BRIAN TAYLOR
STATE FIRE MARSHAL

January 5, 2026

RE: Placement of Swimming Pool in Open Space for Frontage Increase per 2018 North Carolina Building Code (NCBC) Section 506.3

- 1) Appendix E
- 2) Site plan clip of the area in question
- 3) Commentary on 506.3
- 4) Email exchange with Mr. Senada.

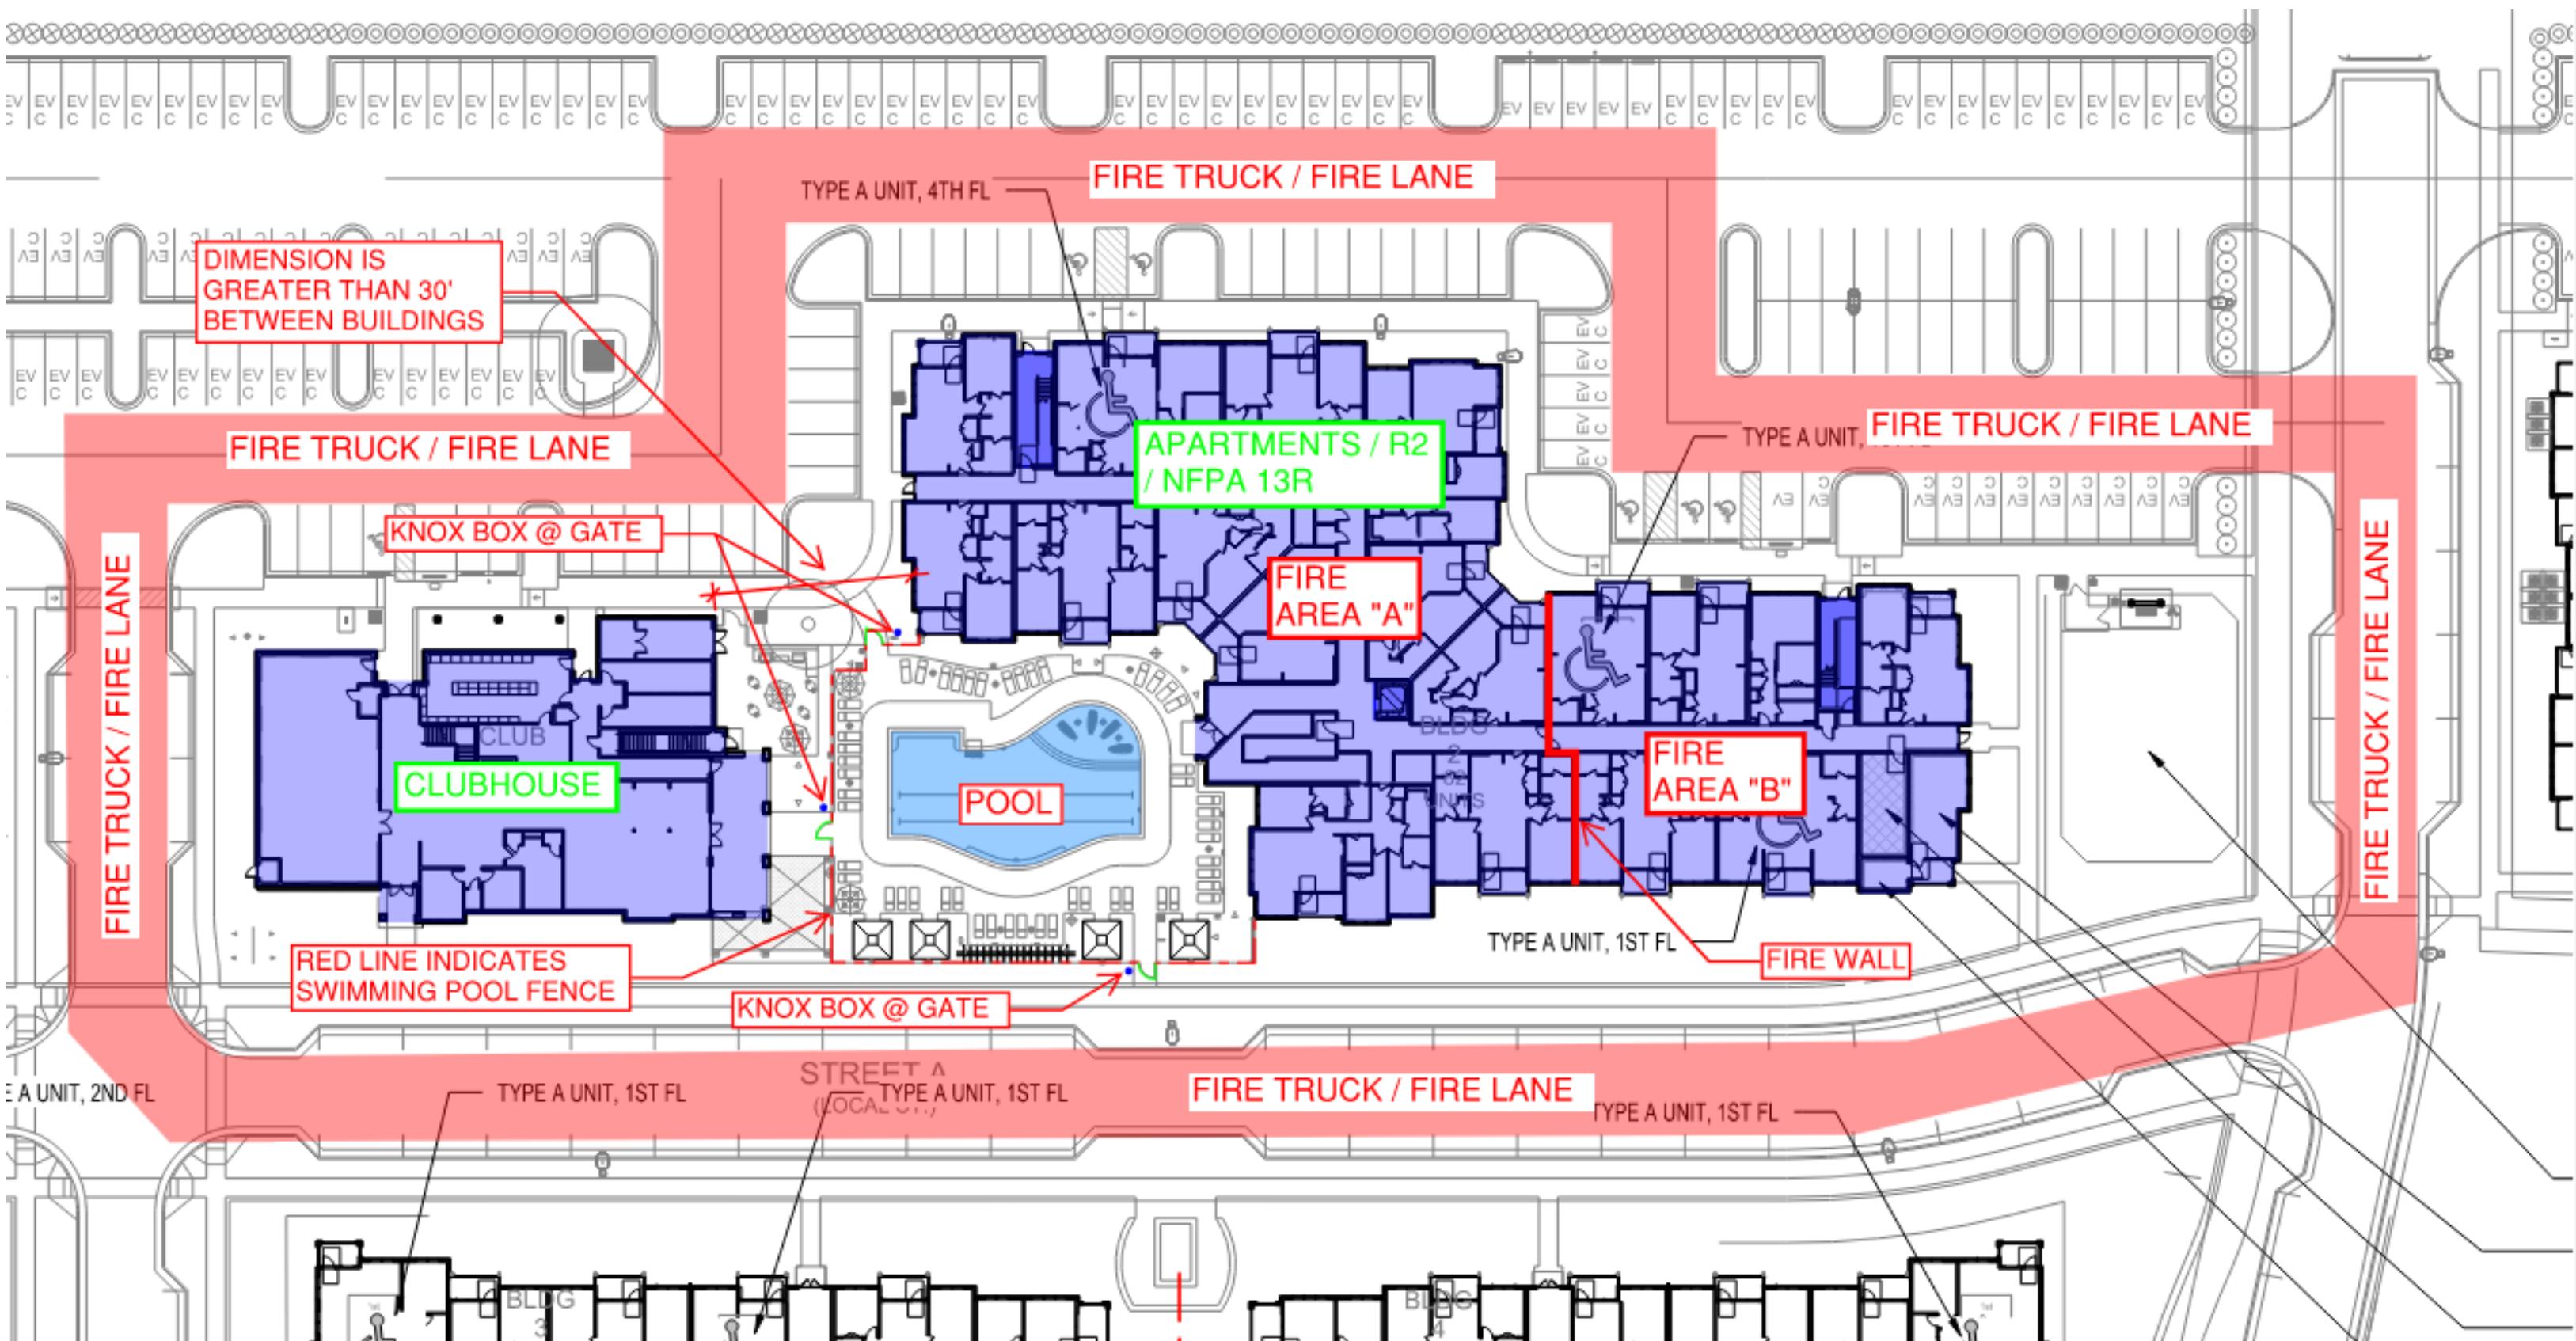
We have a swimming pool located next to the building and we proposed "Knox Boxes" be placed on the pool gates to allow fire department access. We have discussed this with the Town of Chapel Hill & with Mr. Senada of OSFM & have been told that the pool fence and the pool gates prevent fire department access around the building & the swimming pool cannot be located in this "open space" & therefore the "**FRONTAGE INCREASE**" per 506.3 cannot be used for our R2/NFPA 13R building (Fire Area A). We proposed providing Knox Boxes at the pool gates to allow Fire Department access similar to secured building entries, fire pump rooms, fire sprinkler rooms, roof access conditions and fire command centers but were told "Knox Boxes" did not meet code requirements for FD access in 506.3 and therefore the "**FRONTAGE INCREASE**" per 506.3 could not be applied to a building or fire area where a pool and pool deck surrounded by pool fence was placed against the building.

Hopefully I am submitting this correctly. We are requesting a formal Interpretation on a code question regarding whether a swimming pool is allowed to be placed in the 30' open space area of 506.3 for purposes of "FRONTAGE INCREASE" and if knox boxes are allowed on the pool gate for FD access. We have provided a signed Appendix E per the instructions we read online. We have also provided a site plan clip as well as the relevant sections of the code commentary we have been studying. See list of attachments at the bottom of this email. We think the attached site plan clearly shows the condition we are asking about which we face on many of our R2 apartment buildings nearly all of which have swimming pools.

1. A swimming pool represents a permanent, significant change in grade and surface that is inherently non-traversable, creating a physical hazard regardless of its state. When filled with water, the pool acts as an impassable body of water that prevents the "access by fire service personnel" and "hose deployment" required by the code; conversely, when empty, the pool basin constitutes a significant vertical fall hazard and a physical obstruction that prevents the safe movement of personnel and eliminates the "temporary refuge area" required for fleeing occupants. Therefore, the portion of the perimeter obstructed by the pool (including its surrounding deck required for circulation) does not qualify for frontage increase credit.

3. Providing Knox boxes on pool enclosure gates satisfies North Carolina Fire Code requirements for rapid access through secured gates but does not overcome the obstruction created by the pool itself. Fire personnel, once through the gate, would still be unable to utilize the pool area for required emergency operations.

4. To legitimately claim a frontage increase, the swimming pool must be located entirely outside the required 20- to 30-foot open space zone. If the pool remains within this zone, the obstructed segments of the building perimeter must be excluded from the weighted average width (W) calculation in accordance with Equation 5-4.
